Access Compliance Report

Public Rights-of-Way

(Curb Ramps)

Intersection ID: 10837	Main Street: DELIAH_LN	Cross Street: E_W_T_HARRIS_BV	Location: NE
ADA ID: 402037A33573	Ramp Type: PerpDiag	Initial Pass/Fail: Fail	Overall Compliance: No
Severity Score: 10			
Codes/Mitigation Info/Possible Solution		Field Measurements/Component Compliance

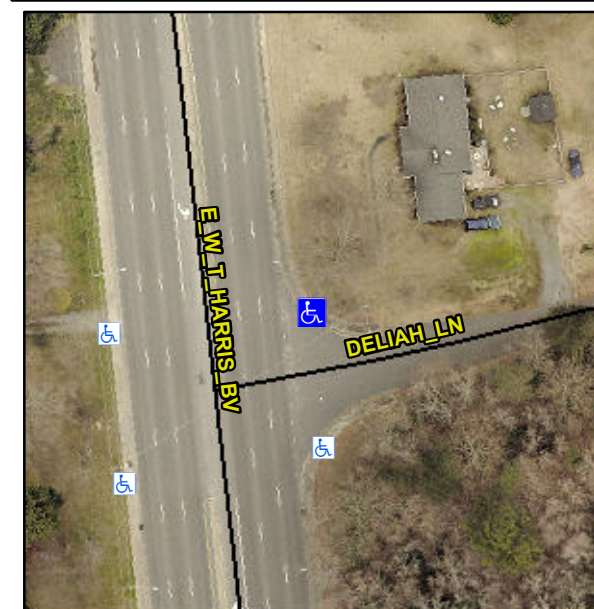
Not Found, R304.5.1, R304.5.3

Compliance	Description	Data	Compliance	Description	Data
N/A	Ramp Length (in)	60.0	Yes	Ramp Slope (%)	8.3
No	Ramp Width (in)	37.0	No	Ramp XSlope (%)	2.5
N/A	Flare Type LT	N/A	N/A	Flare Type RT	N/A
N/A	Flare Slope LT (%)	N/A	N/A	Flare Slope RT (%)	N/A
N/A	Flare Traversable LT?	N/A	N/A	Flare Traversable RT?	N/A
N/A	Landing Length (in)	N/A	N/A	DWS Provided?	N/A
N/A	Landing Width (in)	N/A	N/A	DWS Contrast?	N/A
N/A	Landing Slope (%)	N/A	N/A	DWS Length (in)	N/A
N/A	Landing X Slope (%)	N/A	N/A	DWS Full Width?	N/A
N/A	Landing Curb? (Y/N)	N/A	N/A	DWS Offset (in)	N/A
N/A	Shared Landing?	N/A			
N/A	Gutter Ponding?	N/A	N/A	Gutter Slope (%)	N/A
N/A	Gutter Lip Ht (in)	N/A	N/A	Gutter X Slope (%)	N/A
N/A	Painted X Walk1?	No	N/A	Painted X Walk2?	No
	X Walk 1 Direction	To W		X Walk 2 Direction	To S
N/A	X Walk 1 Width (in)	N/A	N/A	X Walk 2 Width (in)	N/A
	X Walk 1 Slope (%)	1.4		X Walk 2 Slope (%)	0.8
	X Walk 1 X Slope (%)	1.0		X Walk 2 X Slope (%)	1.8

Remove & Replace Curb Ramp With Two New Directional Ramps or Equivalent.
